11. Tuttle Subdivision 2023 Replat; KPB File 2023-120 McLane Consulting Group / Rozak, Pond Location: Moraine Vista Street off the Sterling Highway Kasilof Area

ITEM #11 - PRELIMINARY PLAT TUTTLE SUBDIVISION 2023 REPLAT

KPB File No.	2023-120
Plat Committee Meeting:	November 13, 2023
Applicant / Owner:	Mark and Sarah Rozak, of Kenai, Alaska and Shayne and Pepper Pond of Kasilof, Alaska
Surveyor:	James Hall / McLane Consulting Inc
General Location:	Moraine Vista Street / Kasilof area

Aerial with 5-foot Contours

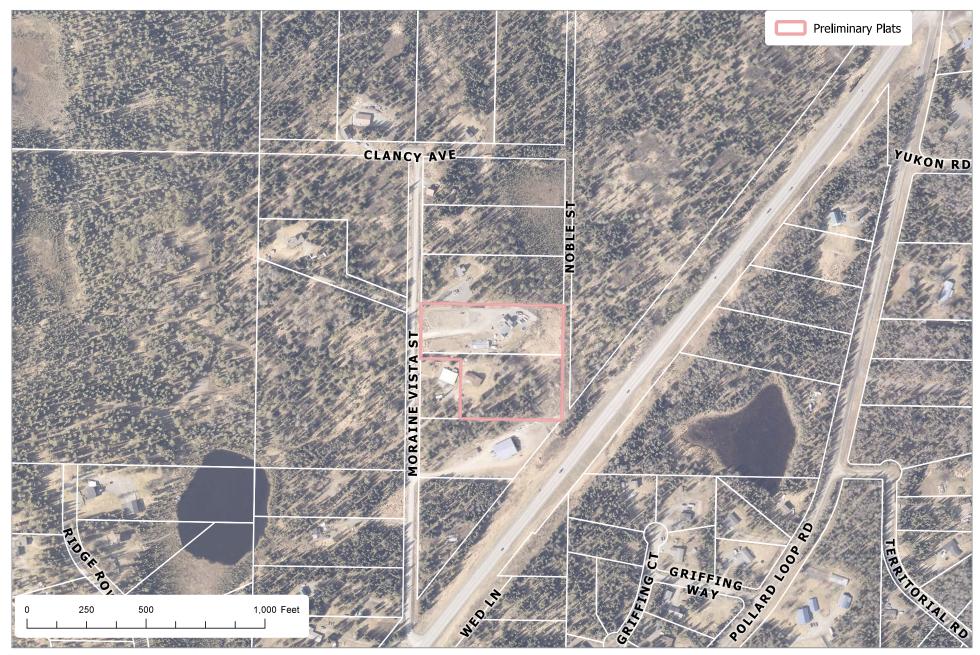
<u>Site Investigation:</u> The contours reveal some steep terrain, but the areas of 20% incline are not identified on the plat. Drainage is to the east and southeast. *Staff recommends:* steep areas be identified on the final.

Staff recommendation: Contours shown but slopes greater than 20% are not labeled or identified on the drawing.
